**CAPITOL ZONING DISTRICT COMMISSION
STAFF REPORT
8/30/17
BIM**

Location: 1401 South Spring Street
Applicant: Ed Sergeant for Chad Dillard
Permit Types: Certificate of Appropriateness

Project Description: This application is for a Certificate of Appropriateness to allow for the construction of a new, one-story detached garage and related site improvements. The approximately 600 square foot structure will be covered in horizontal cement fiberboard lap-style siding and trim. Windows will be one-over-one, single-hung wood or vinyl models. The gable roof is comprised of composition shingles. Two overhead garage doors will face north towards Daisy Bates Dr. The site plan also calls for relocating a curb cut and concrete driveway slightly to the east of their current location, and rebuilding a deteriorated rock wall slightly to the west.

***** UPDATE (2/12/18) ***** See updated analysis of backyard coverage requirements on pages 2-3 and a revised site plan on page 14.

EXTERIOR ELEVATIONS

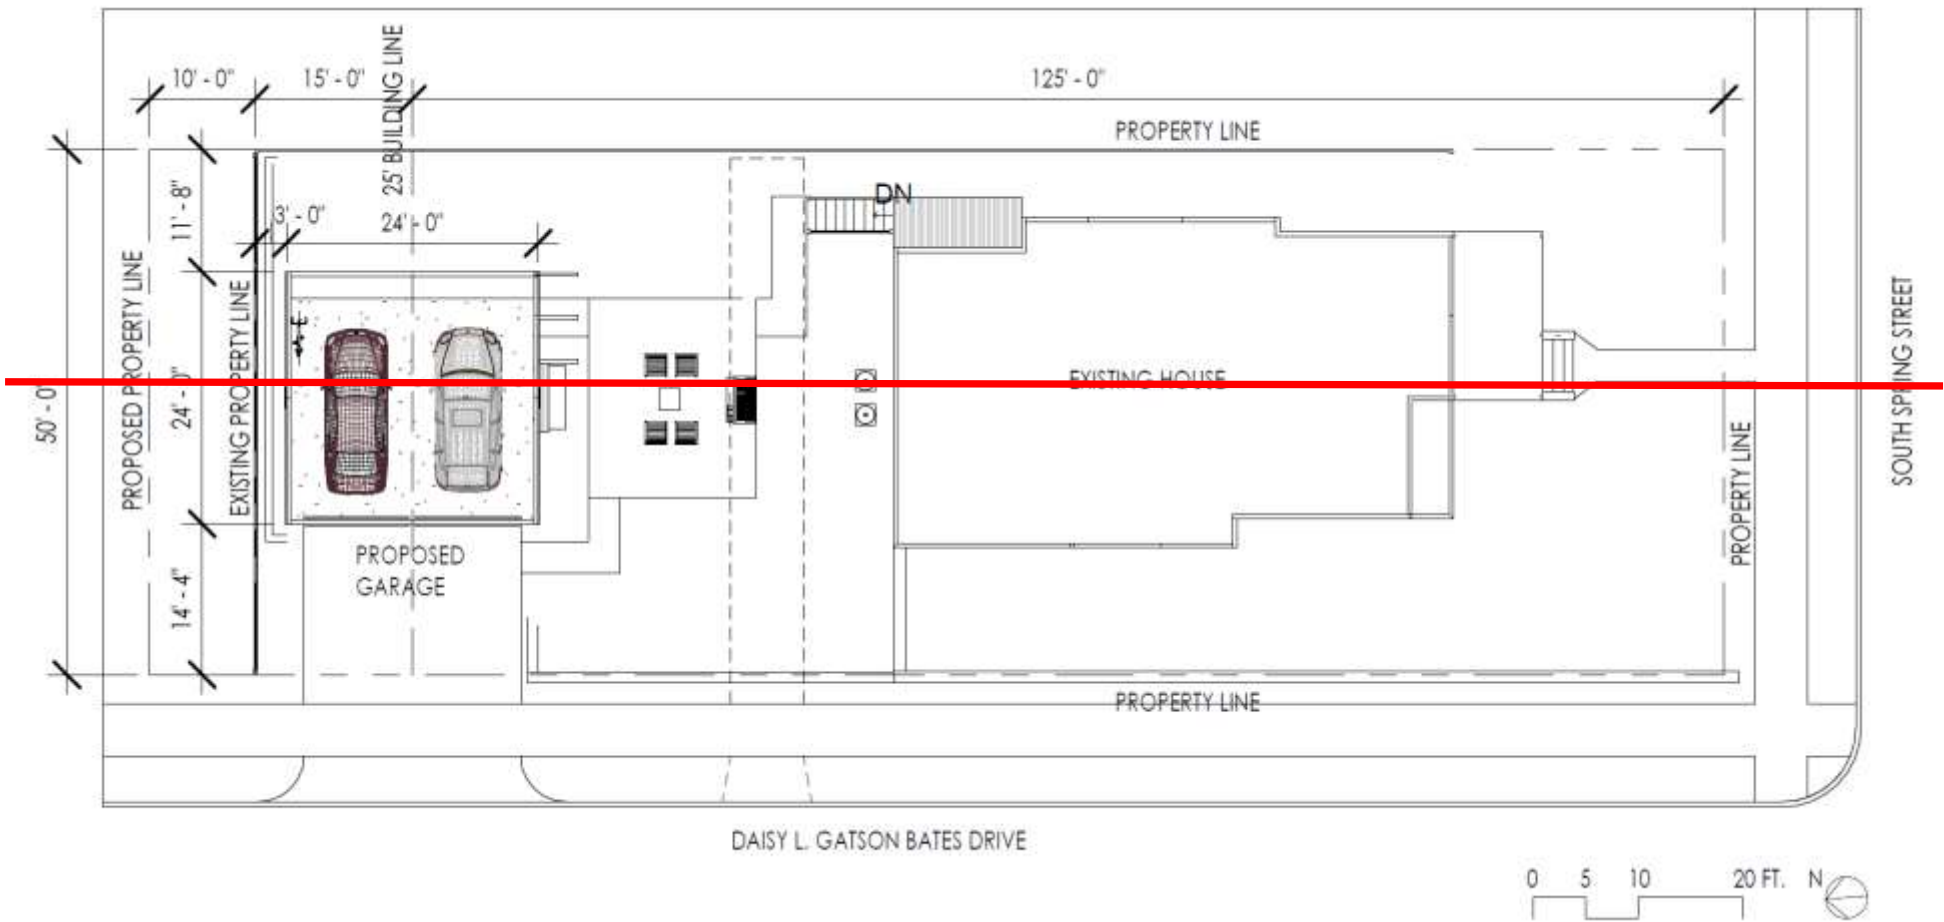
Staff finds the proposal to be consistent with this standard, because of the proposed garage's size and location.

Staff finds the proposed garage to be consistent with these standards.

Staff finds the proposed garage is consistent with these standards.

FLOOR PLAN

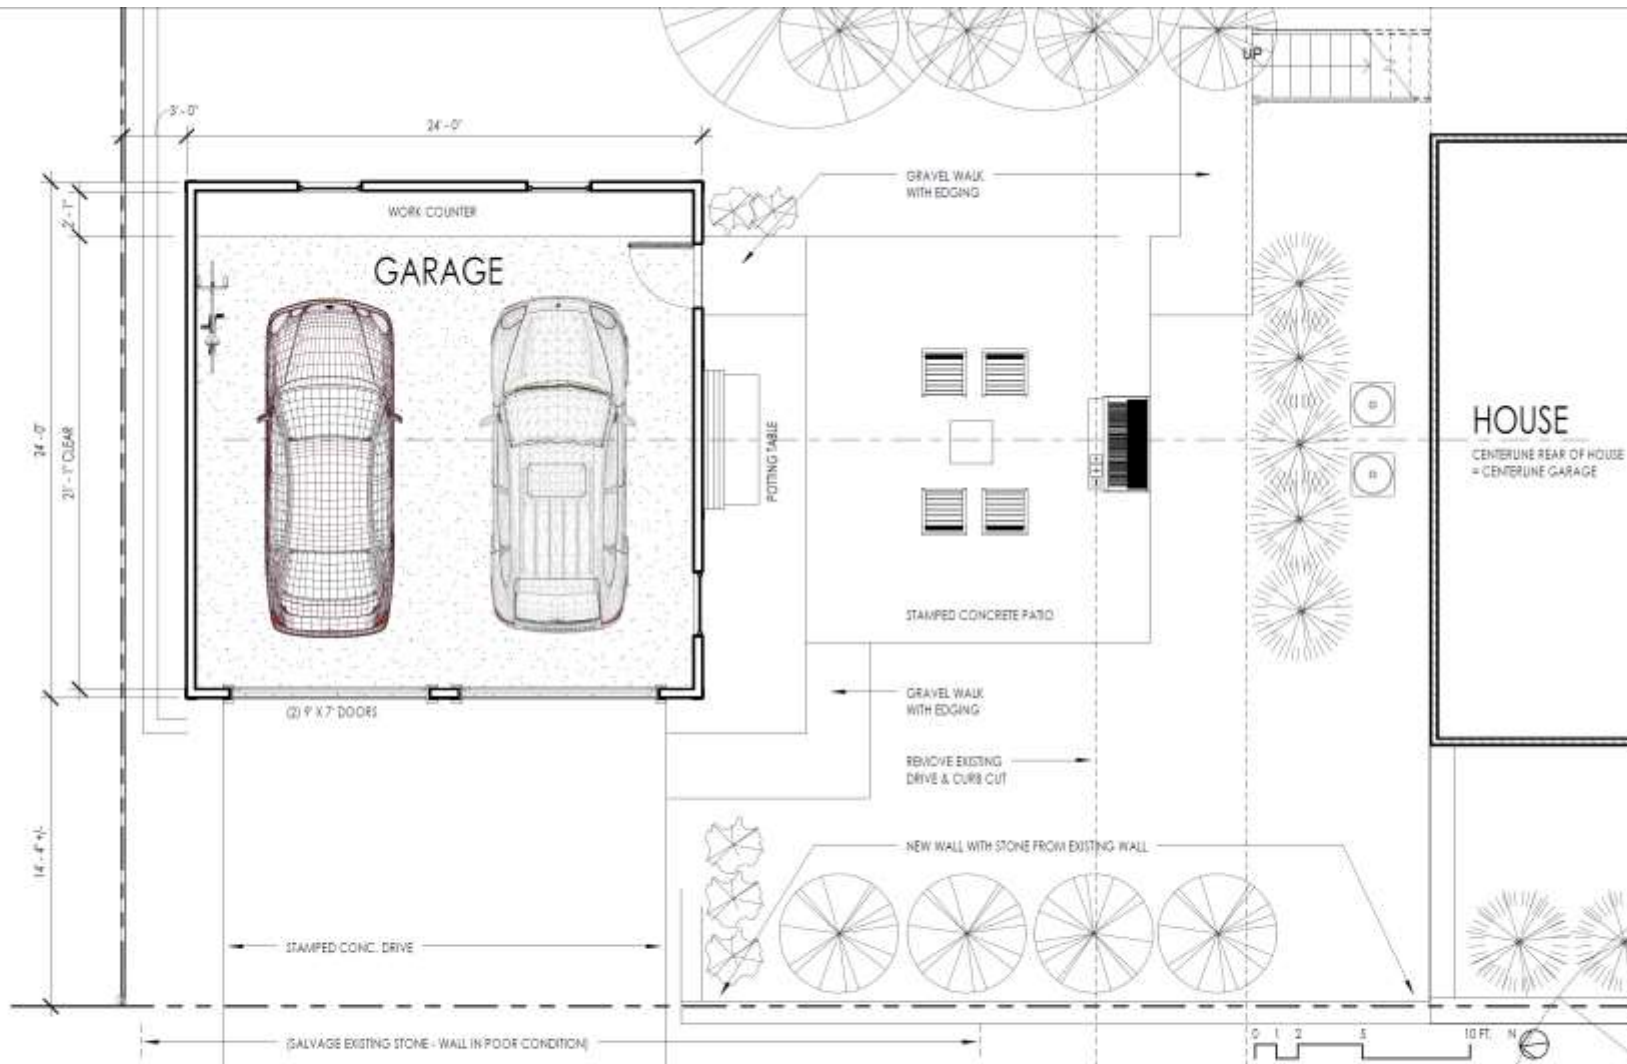
***** UPDATE (2/12/18) ****** See revised site plan on page 14.
